Tennessee Valley Authority, Post Office Box 2000, Soddy-Daisy, Tennessee 37384-2000

SEQUOYAH NUCLEAR PLANT (SQN) - RESPONSE TO NRC REQUEST FOR
ADDITIONAL INFORMATION (RAI) REGARDING ASME SECTION XI
INSERVICE INSPECTION (ISI) PROGRAM RELIEF REQUESTS 1-ISI-23,
1/2-ISI-24, AND 1/2-ISI-25 (TAC NOS. MB9085 AND MB9086)

RESPONSE TO REQUEST FOR ADDITIONAL INFORMATION REGARDING ASME CODE INSERVICE INSPECTION (ISI) RELIEF REQUESTS FOR 1-ISI-23, 1/2-ISI-24, AND 1/2-ISI-25

REVISED INSERVICE INSPECTION (ISI) RELIEF REQUESTS 1-ISI-25 and 2-ISI-25

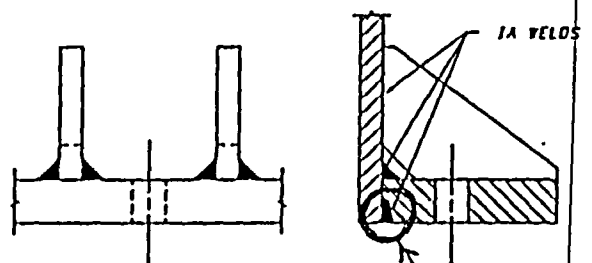
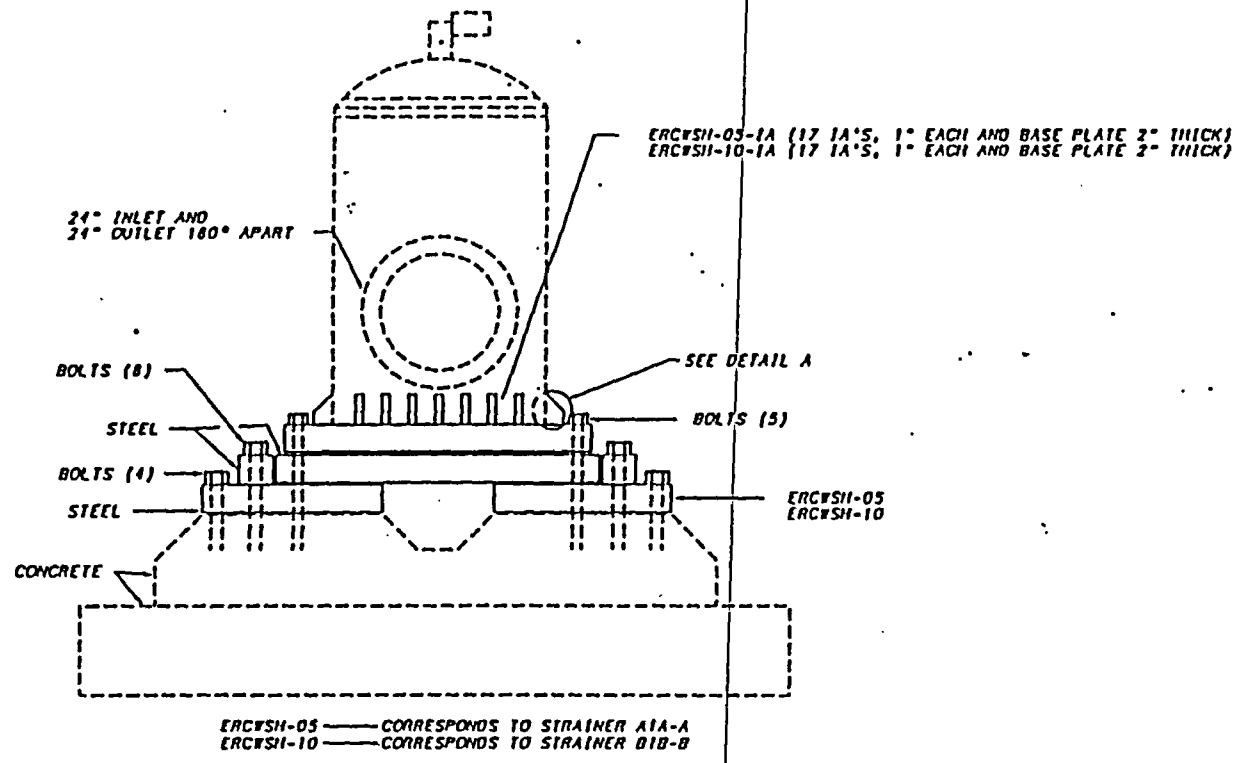
REMARKS: LIMITED EXAMINATION DUE TO INACCESSIBLE WELD REF ISI
REPORT R-5762 (attached) was 8-25-98, App. 75% Coverage achieved.
Unit 1 & Unit 2 assemblies are the same.
See Attached Drawing Approx 67% Coverage See pages
10/20/03 10/20/03 3:4

INACCESSIBLE FOR VT

This memo is notification to update report R7152 to reflect the correct amount of coverage for the visual examinations of integral attachment, and the weldment that was inaccessible for examination due to the component design. The coverage previously reported as approximately 75% is closer to 67%. Re-measurement of weldment and outside diameter of component minus insulation thickness resulted in a more accurate deduction of coverage.

Re-measurement 161" plus (17 IA@10") = 331" plus 161" inaccessible = 492"

$331/492 = 67.3\%$

R7152

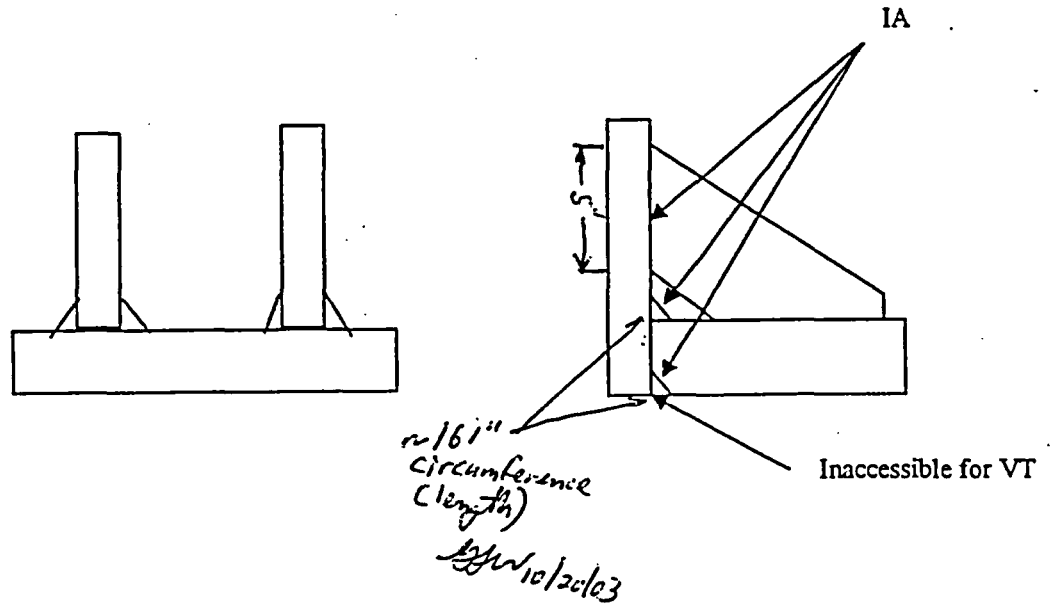
P.E.R. RESOLUTION OF EXAM COVERAGE ESTIMATION:

161" plus (17 IA@10") = 331" plus 161" inaccessible = 492"

$331/492 = 67.3\%$

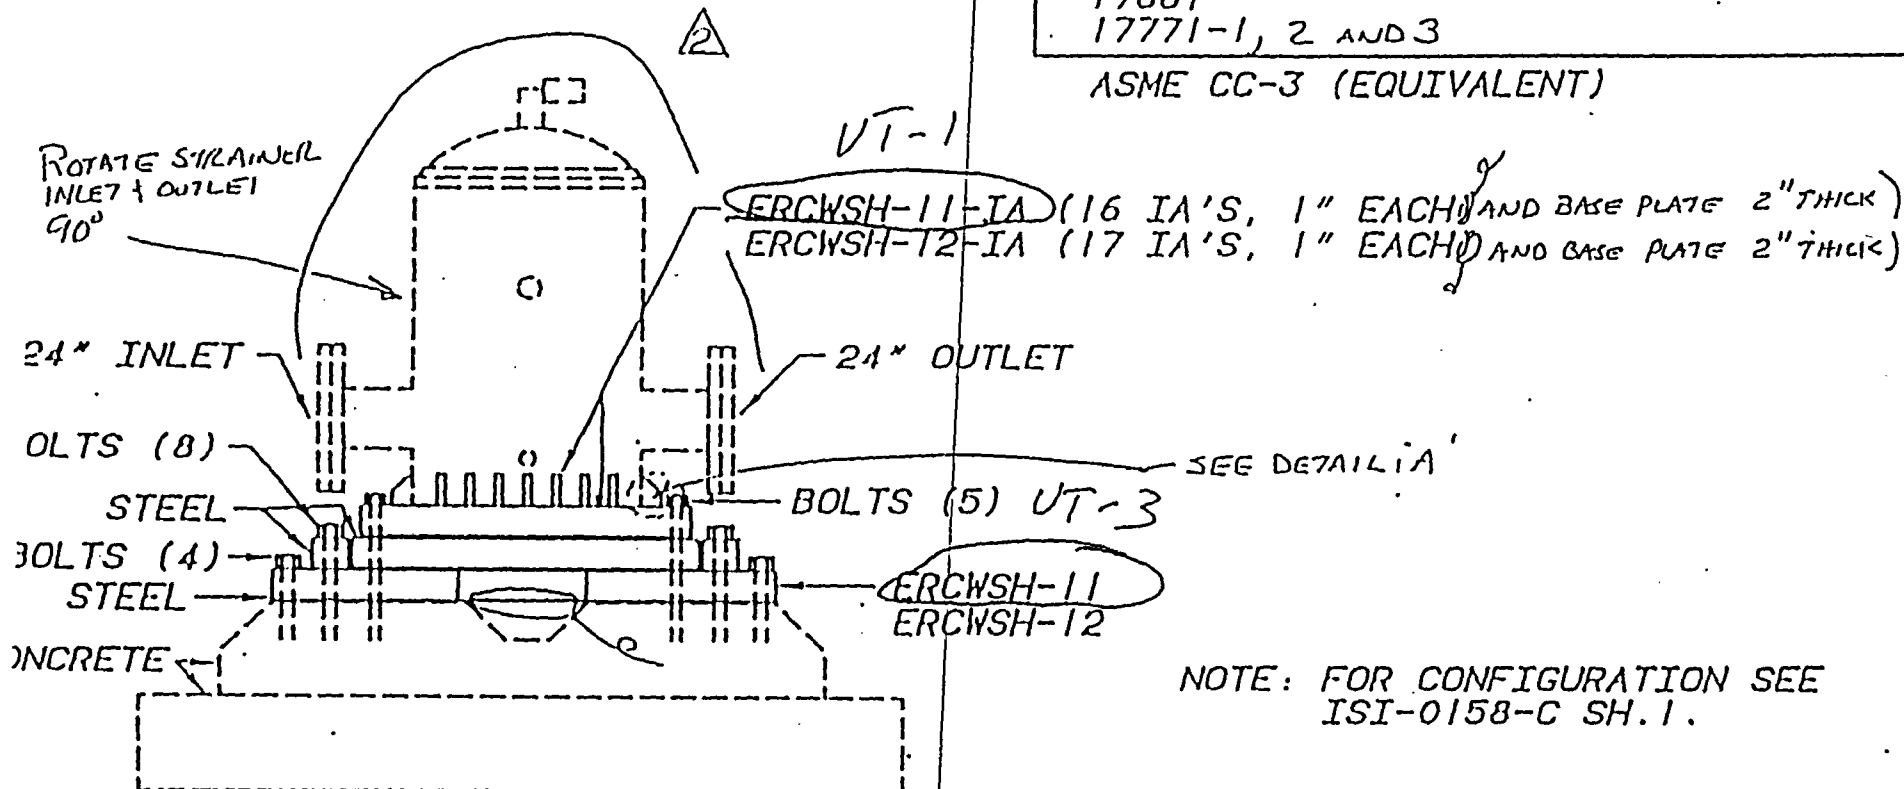
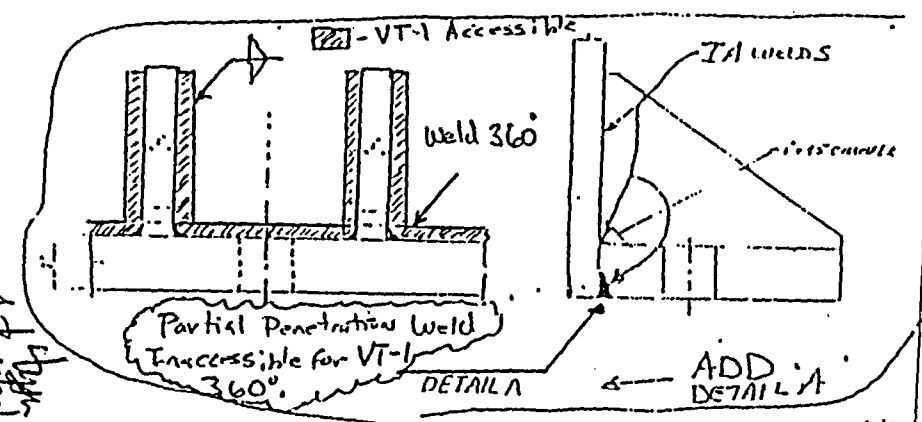
REMARKS: EXAMINATION LIMITED DUE TO INACCESSIBLE PARTIAL

PENETRATION WELD. WELD LENGTH OF INACCESSIBLE WELD = 115"

TOTAL WELD LENGTH = 453" 5/8 9-22-97 454" (2 ROUND SEAMS @ 115"

AND 16 LUGS @ 14" EACH) PERCENT EXAMINED = 7.75%

RET 10/20/03 Apprct 67% Coverage See pages 3 & 4 10/20/03

This memo is notification to update report R 5762 to reflect the correct amount of coverage for the visual examinations of integral attachment, and the weldment that was inaccessible for examination due to the component design. The coverage previously reported as approximately 75% is closer to 67%. Re-measurement of weldment and outside diameter of component minus insulation thickness resulted in a more accurate deduction of coverage.

Re-measurement 161" plus (16 IA@10") = 321" plus 161" inaccessible = 482"

$321/482 = 66.6\%$
